From: [Redacted]
To: [MD Marine Renewables](#)
Subject: Re: 00011544, 00011545, 00011546 & 00011547 - MarramWind Ltd – MarramWind Offshore Wind Farm – EIA Section 36 consent and Marine Licence Applications - Consultation – Response Required by 3 March 2026
Date: 16 February 2026 14:18:22
Attachments: [image003.png](#)
[image309788.png](#)
[image735621.png](#)
[image867318.png](#)
[image622988.png](#)
[image323574.png](#)

00011544, 00011545, 00011546 & 00011547 - MarramWind Ltd – MarramWind Offshore Wind Farm – EIA Section 36 consent and Marine Licence Applications - Consultation – Response Required by 3 March 2026

MarramWind Ltd – MarramWind Offshore Wind Farm – EIA Section 36 consent and Marine Licence Applications – Consultation Response Request

**Extract of EIA Chapter 18
Volume 2 Figure 18.6**

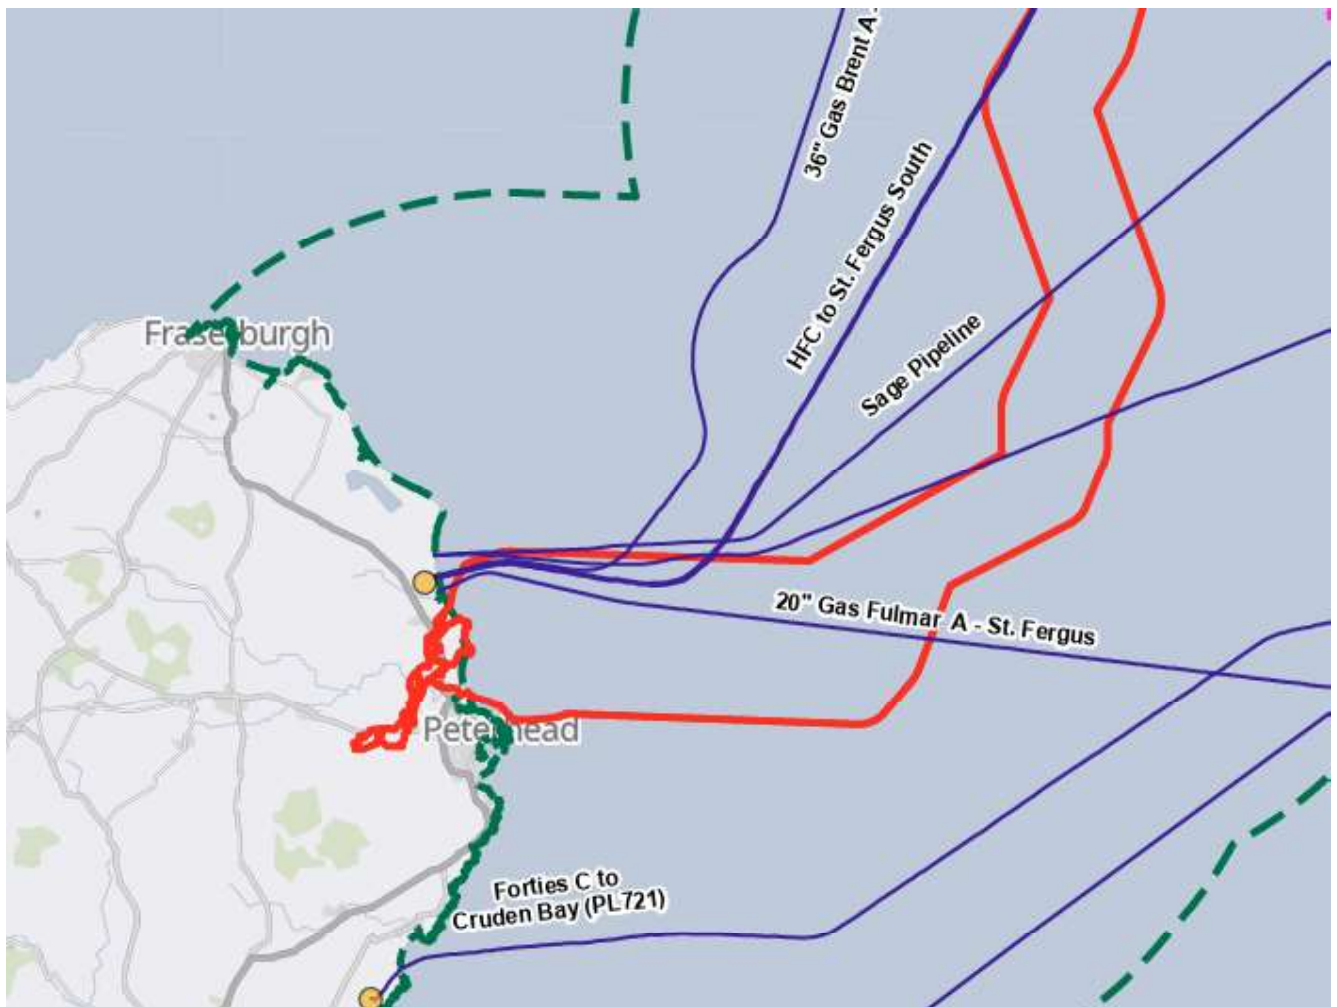
This is consistent with the statement at Paragraph 18.6.1.15 of Chapter 18 of the EIA which identifies that there are multiple pipelines converging towards the north shoreline of the Offshore Red Line Boundary. This is illustrated at Volume 2 Figure 18.6 of the EIA, an extract of which is attached.
